ADDENDUM NO. 2
A New Housing Unit for Newberry County Detention Center
Newberry, South Carolina
Newberry County Government
July 23, 2025

Construction Documents for the above project are hereby amended as follows:

S2.3

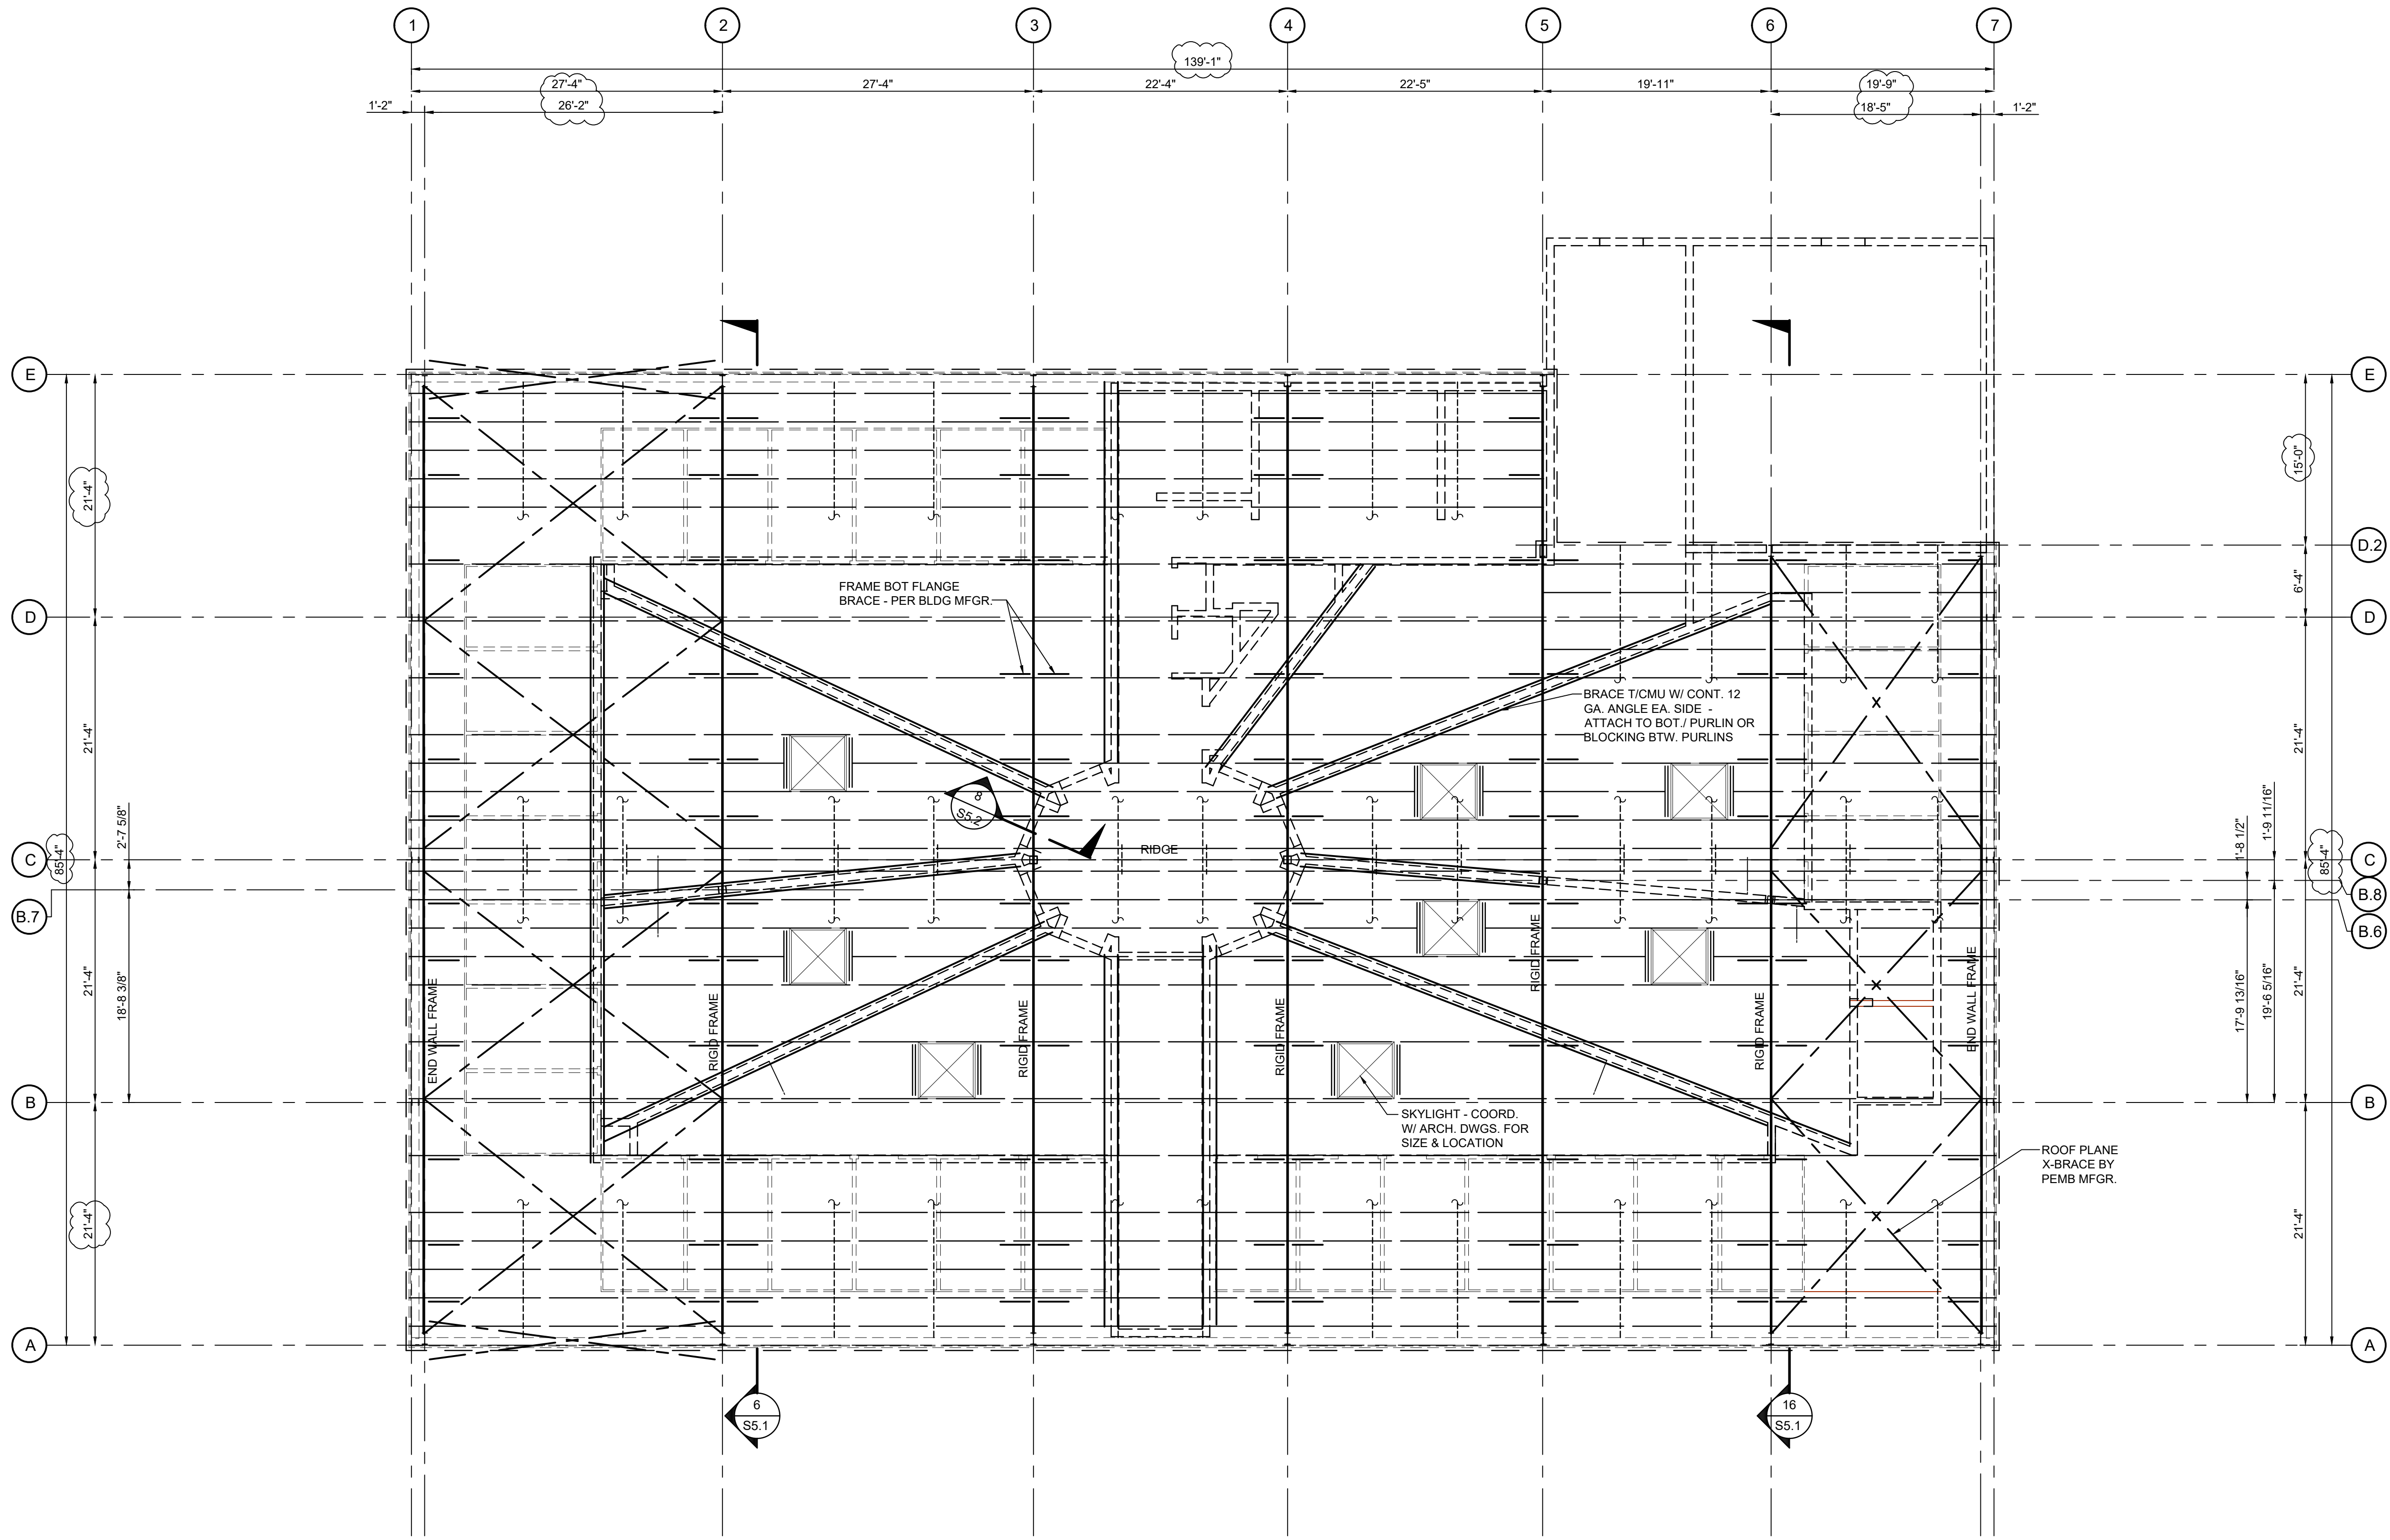
21. Sections 6, 11 & 14 appear to show additional concrete beams at the concrete ceiling areas beyond what is noted on the plans on S2.2 and S2.3 but dimensions are not noted and scaled dimensions are inconsistent. Are any additional concrete beams required other than the 12"x24" and 12"x12" beams noted on S2.2 and S2.3? If so, please provide locations, dimensions and reinforcing information.
Only beams shown are required.

35. Sheet S2.3 notes concrete cap slab on top of cell pods – see arch. Dwgs for addit. Info”. The architectural plans do not provide any information regarding concrete topping at cells. Please provide a plan that shows required locations as well as concrete thickness and reinforcing (if any).
Disregard note. Concrete topping is not required.
